**Consideration and vote by AC.3 of draft gtrs and/or  
draft amendments to established gtrs - Proposal for  
Amendment 2 to gtr No. 3 (Motorcycle braking)**

### **Proposal for Amendment 2 to global technical regulation No. 3 (Motorcycle braking)**

#### **Submitted by the Working Party on Brakes and Running Gear\***

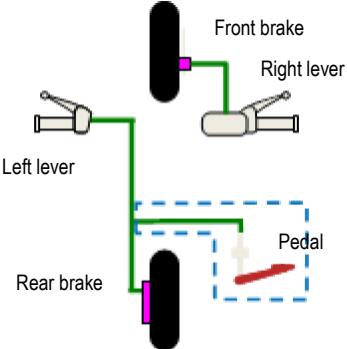
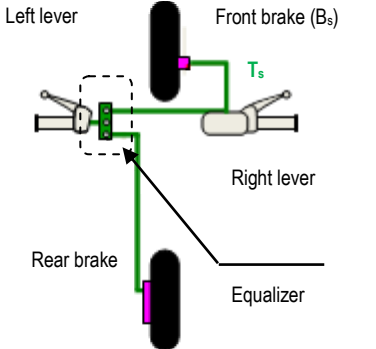
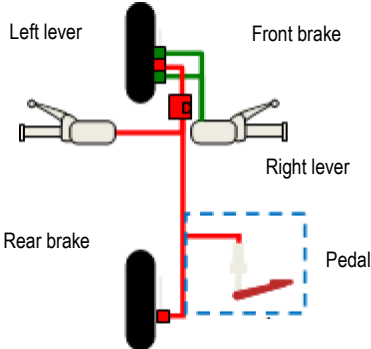
6. Gtr No. 3, paragraph 3.1.9., requires that "two separate brake systems may only share a common brake if a failure in one system does not affect the performance of the other", limits the application of CBS.

7. Not all CBS architectures can meet this requirement although they will outperform conventional brake systems.

8. Not all CBS architectures, however, existed at the time the original CBS requirements were drafted (in the 1980s) and it is, therefore, understood that GRRF did not consider such systems when introducing this requirement.

9. In order to ensure that, in case of a failure in one system, the performance of the other system still equals that of a conventional system, it is proposed to allow two separate brake systems to share a brake and/or a transmission, provided that the other system meets the single brake system performance requirements in case of a failure of such shared components(s). To that end, a failure test is proposed for CBS brake systems of Architecture B. Italy is of the opinion that such a failure test requirement should ensure the acceptance of such a CBS in terms of demonstrated robustness and guaranteed minimum braking performance.

**CBS Architecture B**

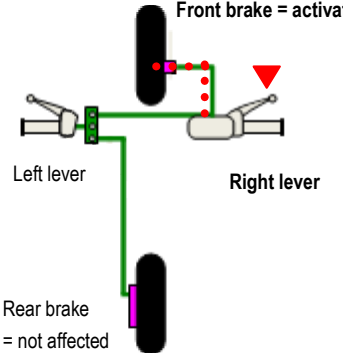
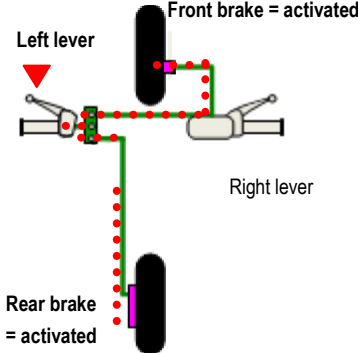
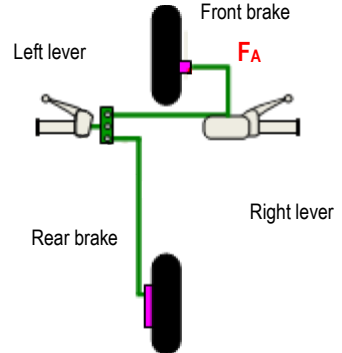
21. Architecture B is an example of a CBS that shares a transmission (Ts) and a brake (Bs).

22. While a failure in e.g. the "front system" ( $F_A$ ) may affect the performance of the CBS, the rear system (operated by the left lever) will continue to be operational.

23. In order to ensure that, in case of a failure in one system, the performance of the other system still equals that of a conventional system, it is proposed to allow that two separate brake systems share a brake and/or a transmission, provided that the other system meets the single brake system performance requirements in case of a failure of such shared component(s). To that end, a failure test is proposed for CBS brake systems of Architecture B. Italy is of the opinion that such a failure test requirement should ensure the acceptance of such a CBS in terms of demonstrated robustness and guaranteed minimum braking performance.
